P94-001 - 5531 CALLISTER AVENUE

- REQUEST:
- A. Special Permit to construct a 530± square foot second residential unit on 0.15± developed acres in the Standard Single Family (R-1) zone.
 - B. Variance to reduce the sideyard setback from 5 feet to 0 feet for a second residential unit.
 - C. Variance to reduce the rear yard setback from 15 feet to 11± feet for a second residential unit.

LOCATION: 5331 Callister Avenue
005-0121-035
Sacramento City Unified School District
Council District 3

EXHIBIT C-1

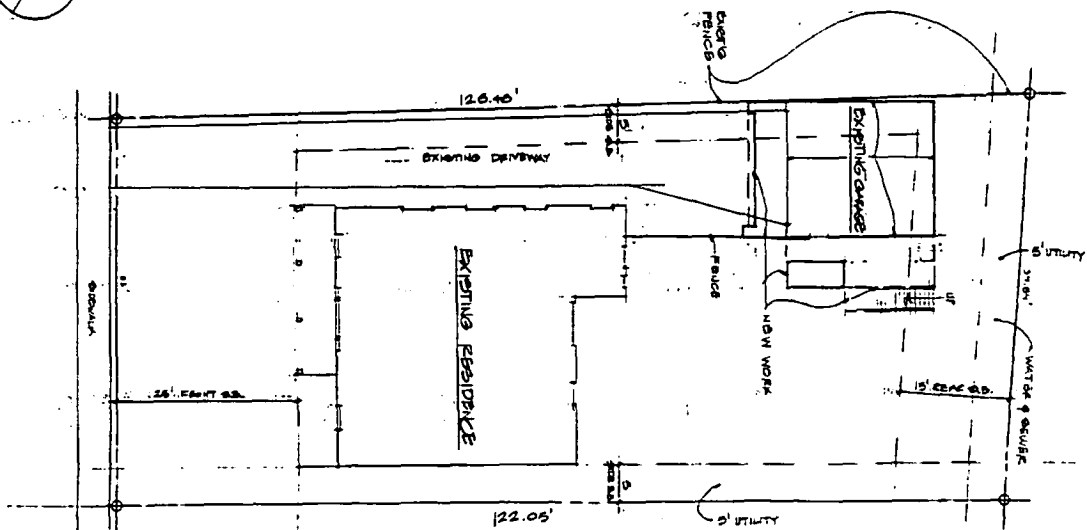
The subject site is developed with a 1200± square foot single family residence and a 360± square foot detached garage. The site is located in a single family residential area in which the standard setbacks for a residential unit are 25 feet in the front, 15 feet in the rear and five feet on the sides. This property as well as several properties in the area have detached garages. Detached garages if located more than 60 feet from the front property line may be constructed on the side property line and encroach up to 25% into the rear setback area. Currently, the existing detached garage conforms to these requirements, as it is 92 feet from the front (west) property line, 25' from the side (south) property line, 11 feet from the rear (east) property line and 0' on the side (north) property line.

The applicant proposes to construct the second residential unit over the existing detached garage. Because of the different setback for detached garages and second residential units, variances are required. Residential units are required to provide a five foot sideyard setback and a 15 foot rear yard setback and be a minimum of 15 feet from the main building if there is an entrance on either building. Since the garage currently exists on the property line and encroaches into the rear setback the applicant is unable to provide the required setbacks. Staff supports the variance requests to reduce the side and rear setbacks. The north elevation will be required (per UBC) to be constructed with a one hour fire wall and no windows or openings allowed. The 11 foot rear setback will be adequate to provide for light and air and adequate rear yard space.

EXHIBIT C-3

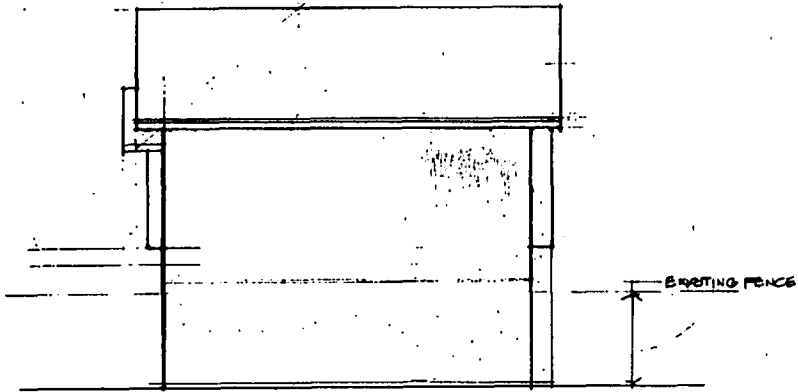
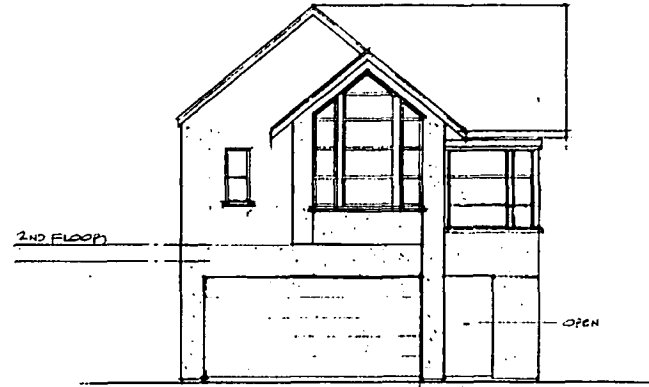
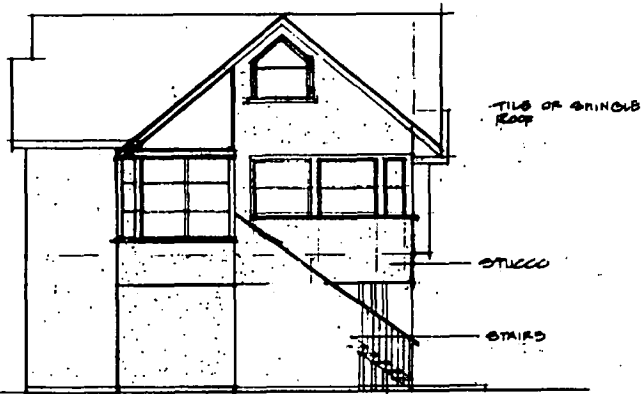
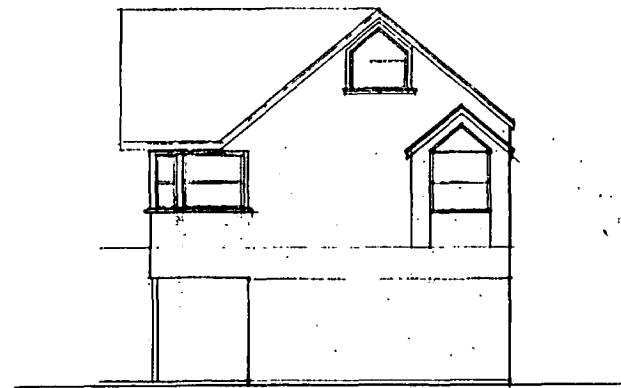
The applicant originally proposed a unit which would have a 23 foot wall height (north elevation) and measure 28 feet to the top of the roof (Attachment D-1). In reviewing the applicant's original plans, staff suggested that the height of the building on the property line was too high and asked the applicant to lower the

height of the structure. The applicant has revised his plans twice. The elevation on the north has been reduced to an 18 feet wall height and 27 feet to the top of the roof (Exhibit C-3).

The applicant has shown these elevations to the adjacent neighbor. The neighbor feels that these are an improvement but objects to the building being on the property line. The applicant is prepared to screen the structure by providing landscaping on the north and east elevations. The landscaping provided on the north elevation would require approval of the adjacent property owner since the landscaping would be on the adjacent property.
